RE: Request for Approval of the Clews Subdivision located at 799 South Street, Tax Map 132 / Lot 24

On behalf of the Noele M. Clews Revocable Trust we hereby submit a request for Subdivision Approval at 799 South Street. The project team met with the Technical Advisory Committee on July 2, 2019 to review the proposal. The Technical Advisory Committee voted to recommend Preliminary and Final Subdivision Approval with the stipulations listed herein. Responses to the stipulations are highlighted in **Bold Text**:

CLEWS SUBDIVISION
799 SOUTH STREET
PORTSMOUTH, N.H.

**LOT 1 DRIVEWAY
SIGHT DISTANCE
PLAN AND PROFILE**

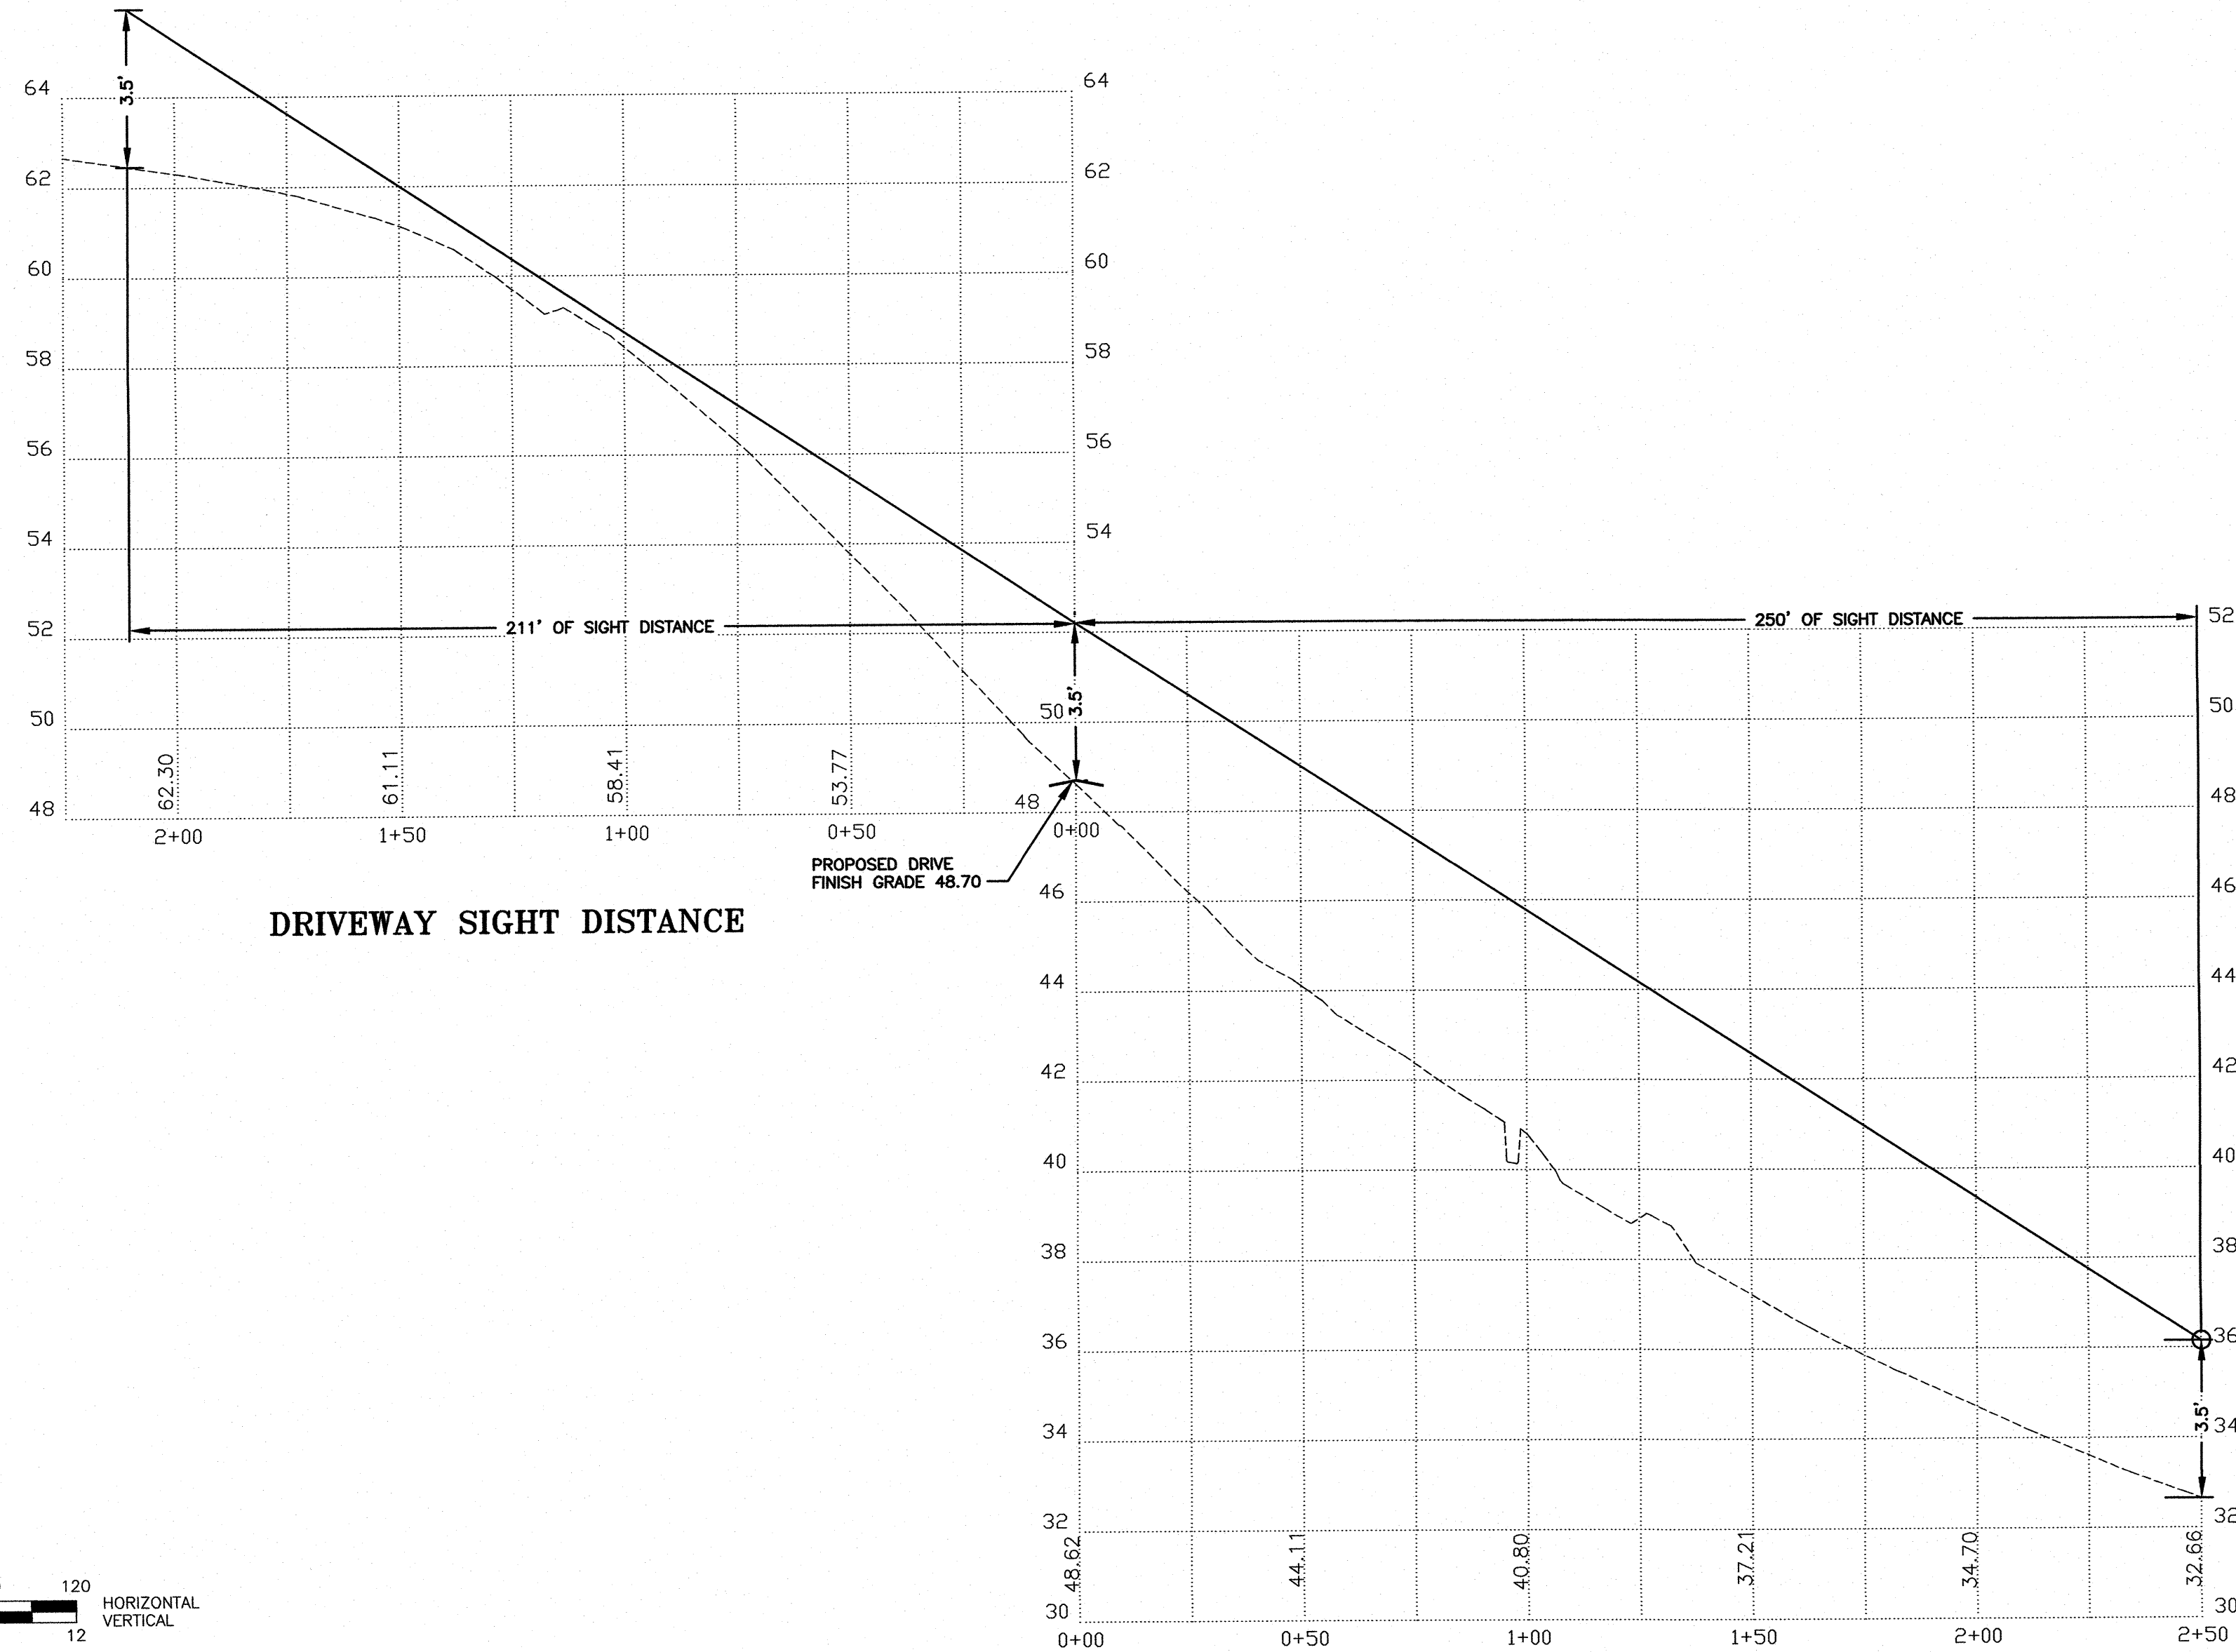
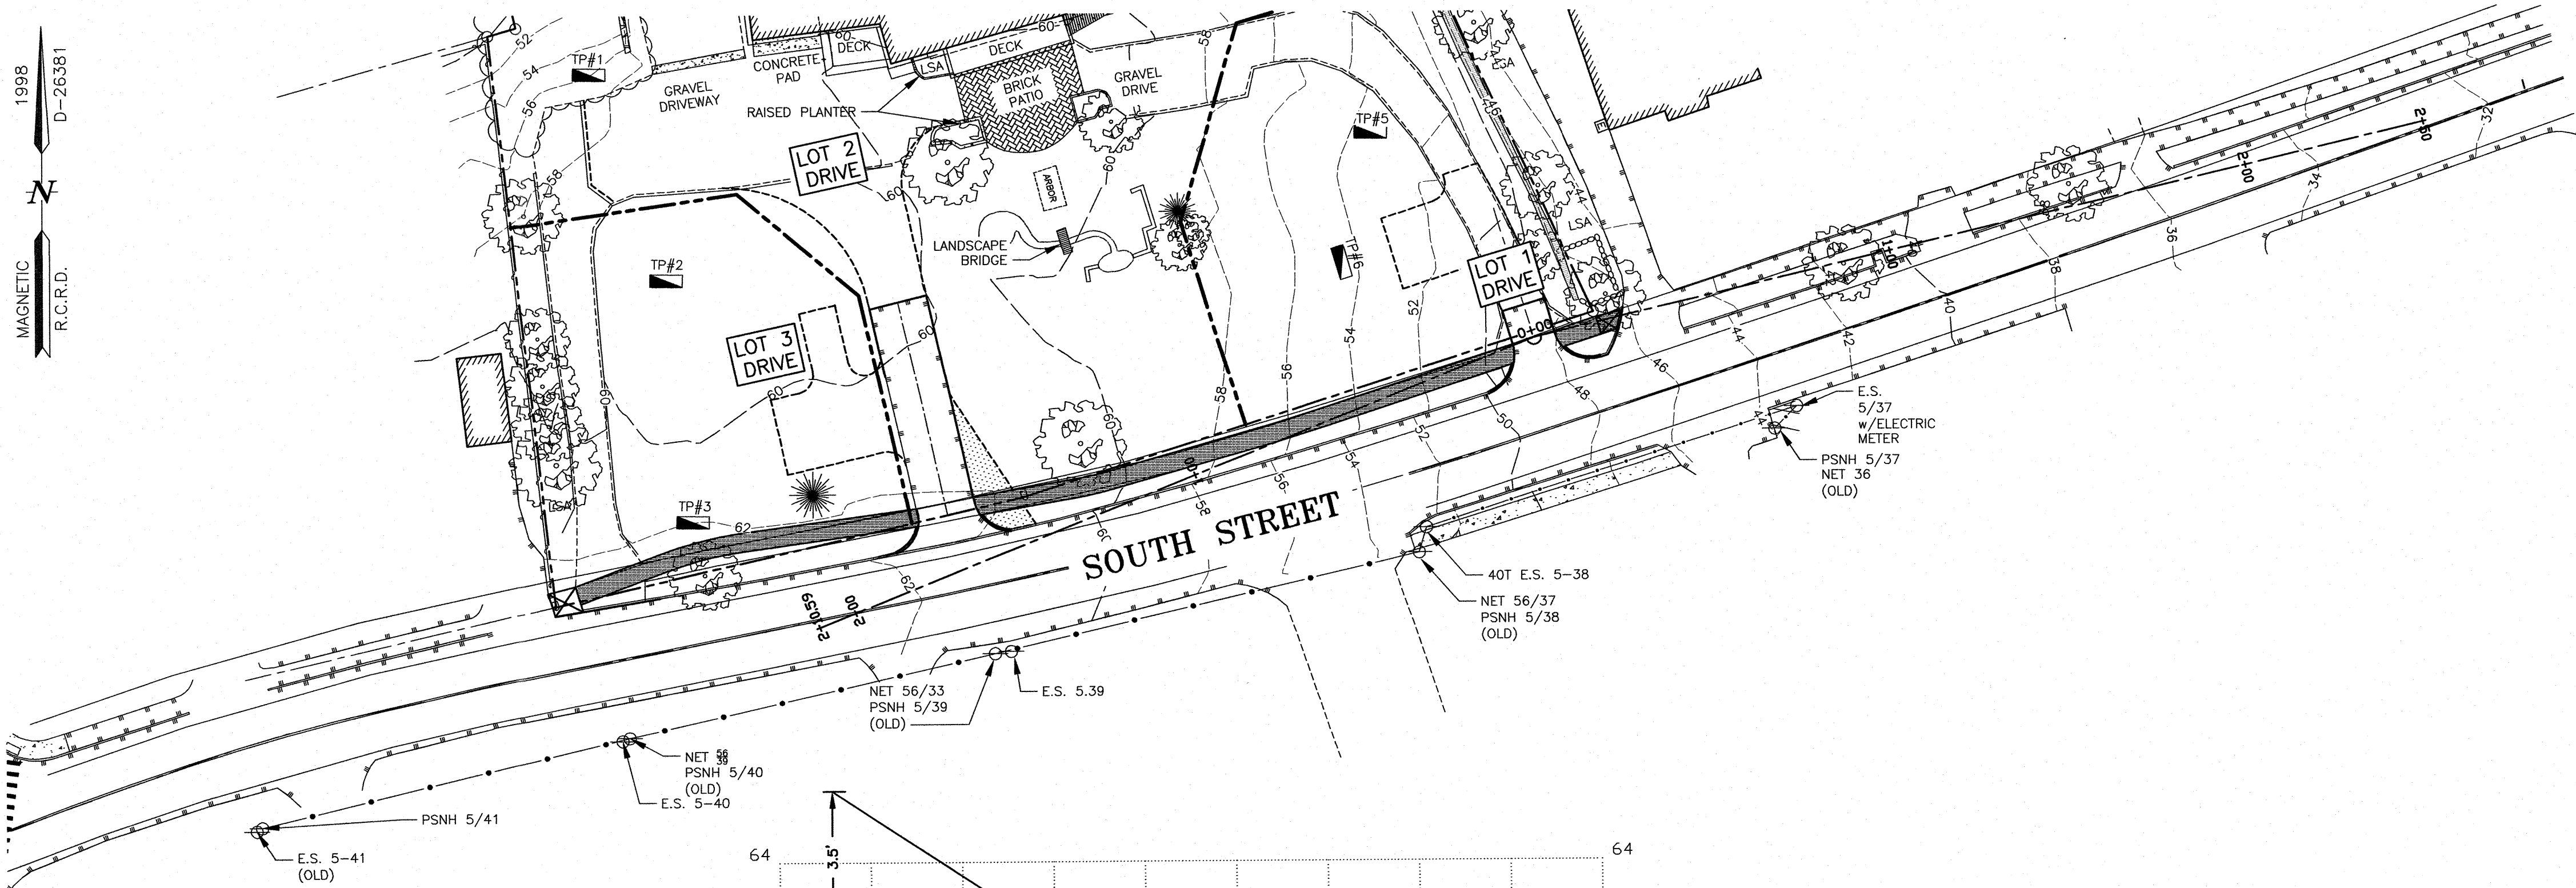
2. The sight distances in both directions at each driveway should be verified on a profile plan of the roadway to be reviewed and confirmed by Eric Eby, the City's Transportation and Parking Engineer. **Site distance profiles have been provided in the plan revised plan set. After review, the driveway location for Lot 1 was relocated to the existing lower driveway. The plans now show that we have adequate driveway site distance in both directions at both driveways. We have followed up with the Parking and Transportation Engineer, Eric Eby, and attached his email stating that he is satisfied that the site distance requirements have been met.**

Thank you for the plans. After reviewing both of the sheets, I am satisfied that the minimum sight line requirements will be met at the Lot 1 Driveway. Let me know if you need anything else from me.

16' WIDE DRIVE EXHIBIT

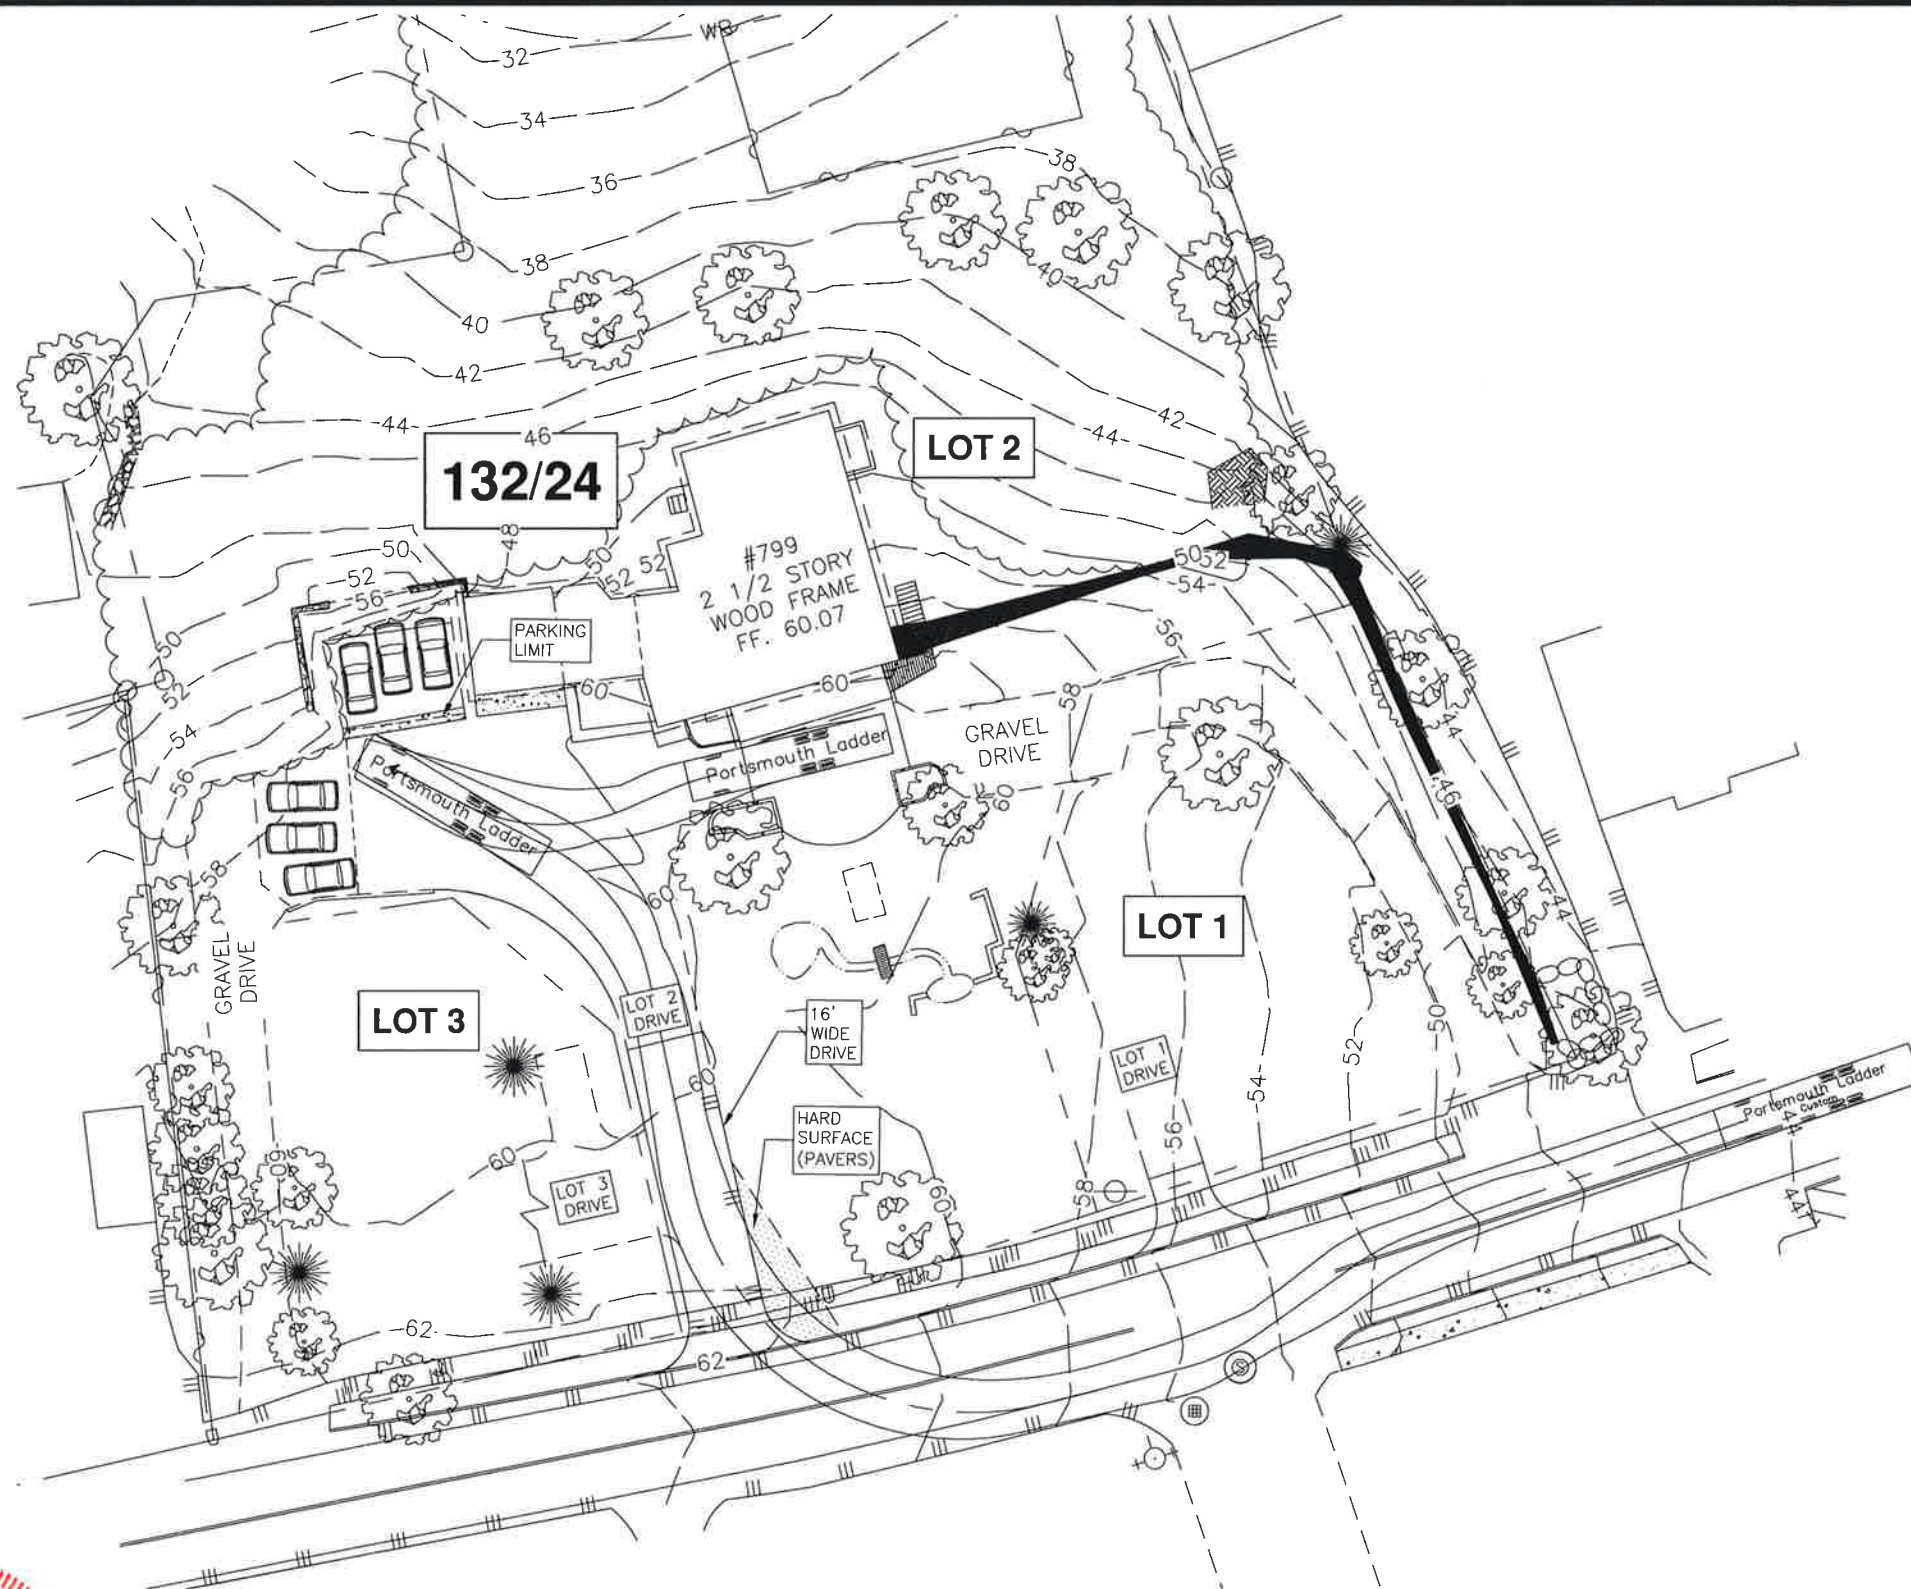
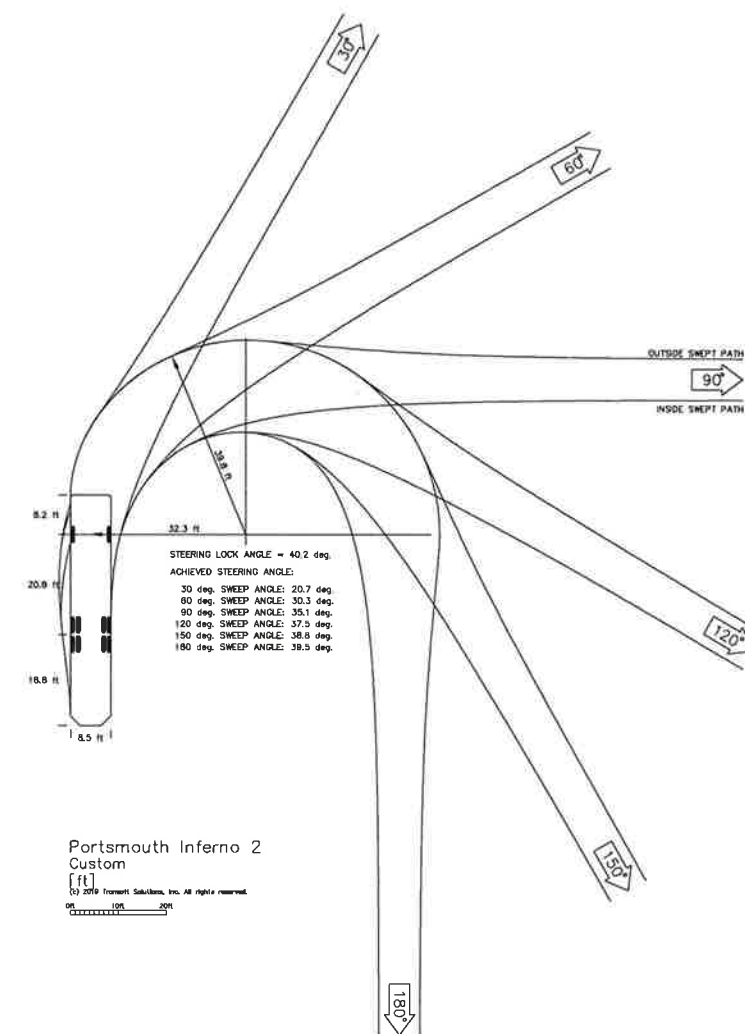
7. Update turning template for fire truck to show cars parked in proposed parking spaces. **The turning template for the fire truck has been updated showing movements with cars parked in the proposed parking space and a 16' wide driveway. See the Fire Truck Turning Plan submitted herewith. We have attached an email from Deputy Fire Chief, Patrick Howe stating the 16' wide driveway is acceptable.**

You are correct. The T5 Ladder Truck has very little room for error.
